ST. LUCIE PLANT UNIT NO. 2

AMENDMENT TO FACILITY OPERATING LICENSE

Amendment No. 17
License No. NPF-16

ATTACHMENT TO LICENSE AMENDMENT NO. 17

FIGURE 3.2-3

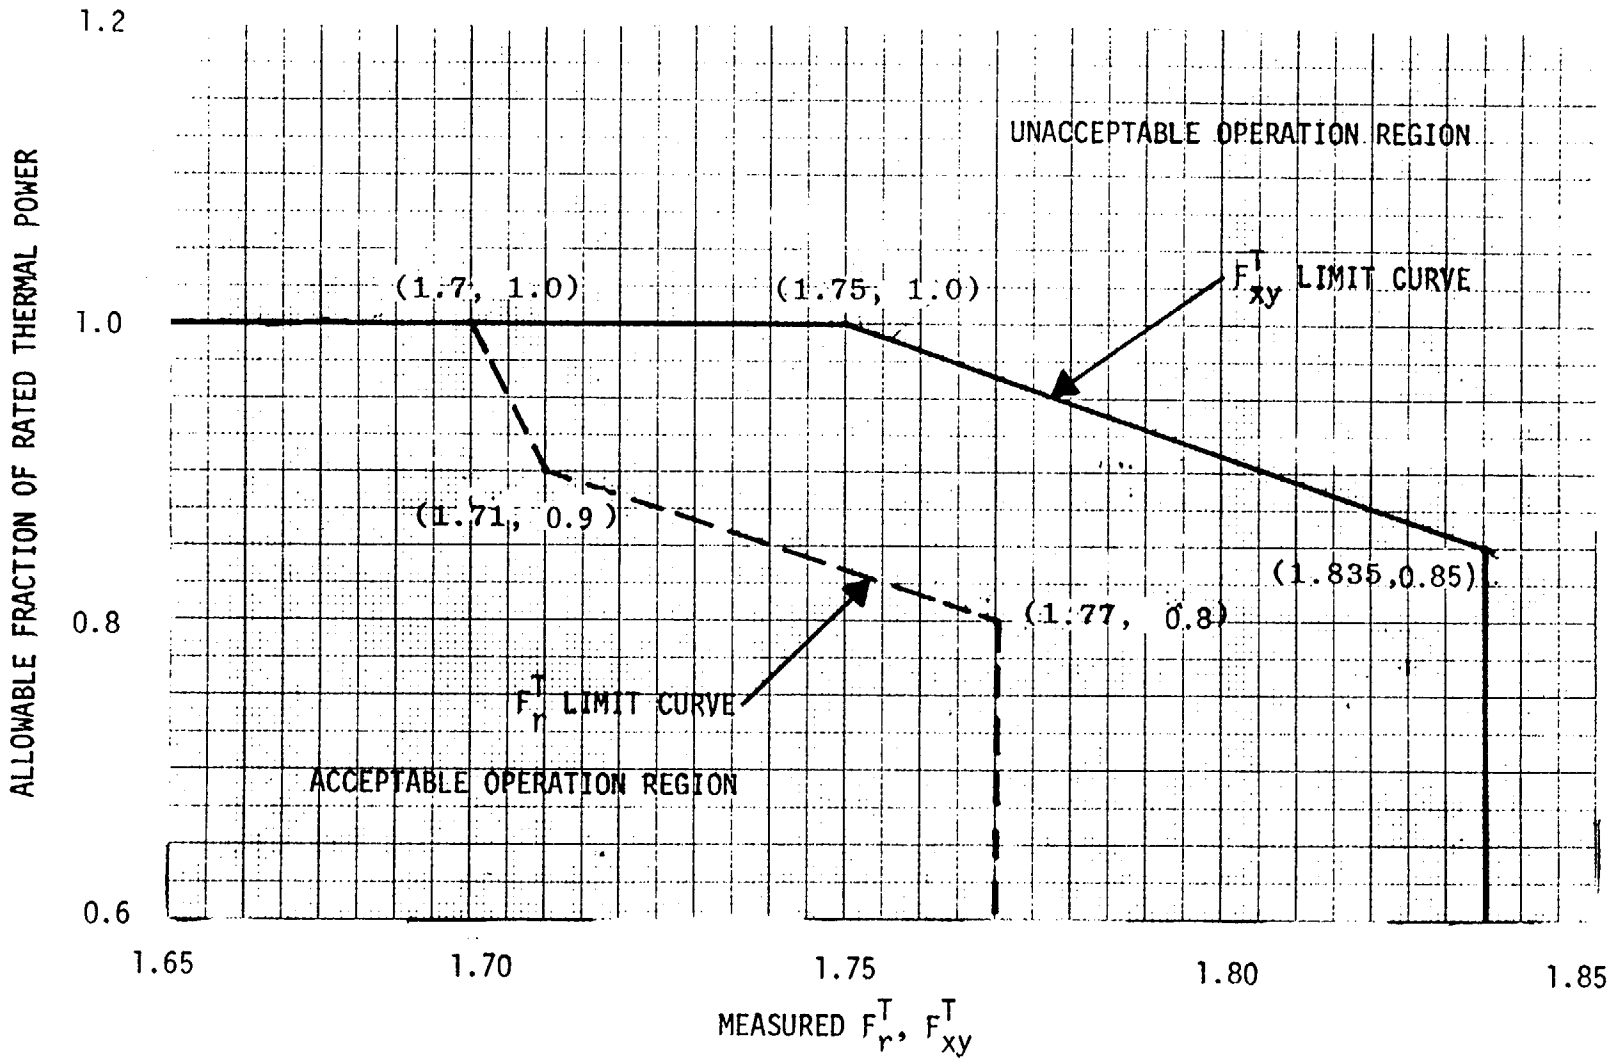
1. M is the maximum allowable THERMAL POWER level for the existing Reactor Coolant Pump combination.
2. N is the maximum allowable fraction of RATED THERMAL POWER as determined by the F_{xy}^T curve of Figure 3.2-3.
